software release note for KUHNT configurations program

software REV 2.0 (BUILD 1.56 v. 04.03.2003)

Change of user panel of the KUHNT configuration software 2.0 (build 1.56)

Radio Settings:

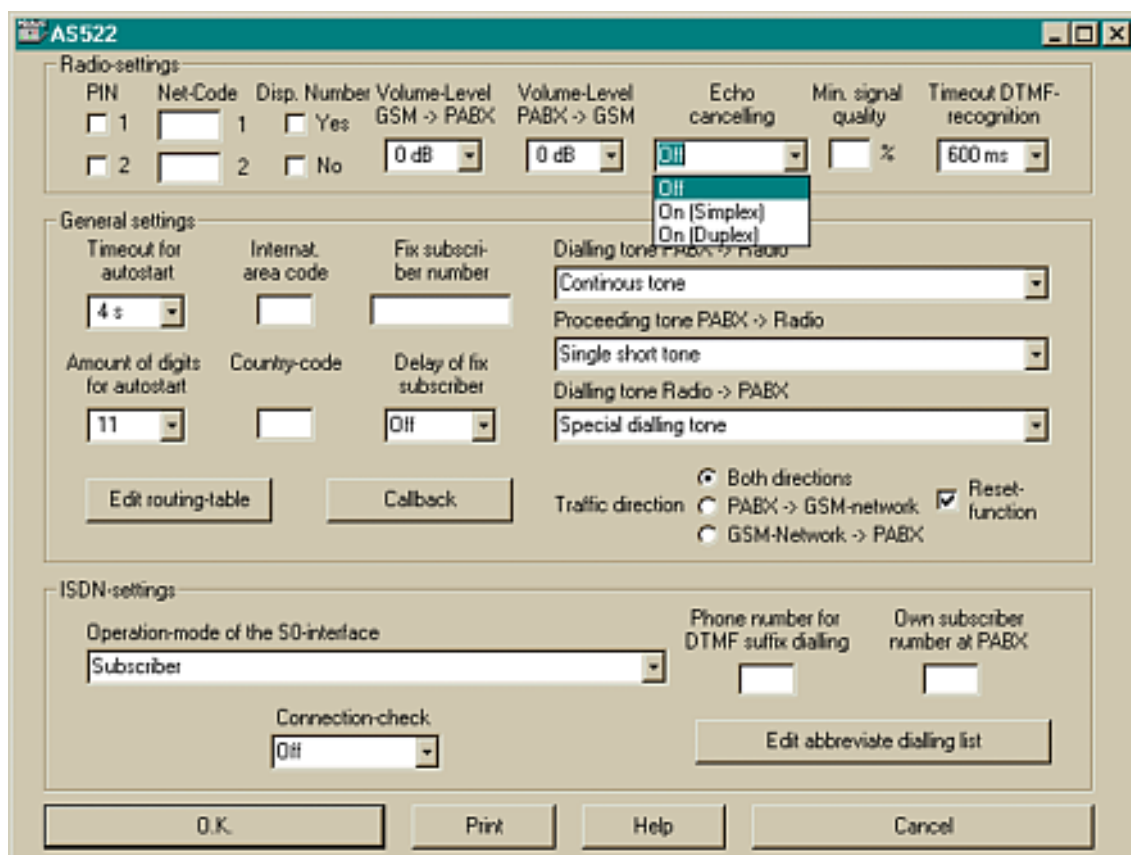
The user panel of the KUHNT configuration program changed in the "*Radio Settings*", especially the specification of "*simplex*" and "*duplex*" is different now. .

old specification:

*operation mode
of the interface*

"*simplex*" and "*duplex*" available. "*simplex*" means echocancelling is active. "*duplex*" means no echo cancelling (echo may occur)

new specification:

Echocancelling:

Depending of type and software of the AS52X interface you can use different presets to manage how the echo cancelling works.

For AS522 with firmware 4.1 and higher:

"*off*"

"*on (Duplex)*"

"*on (Simplex)*"
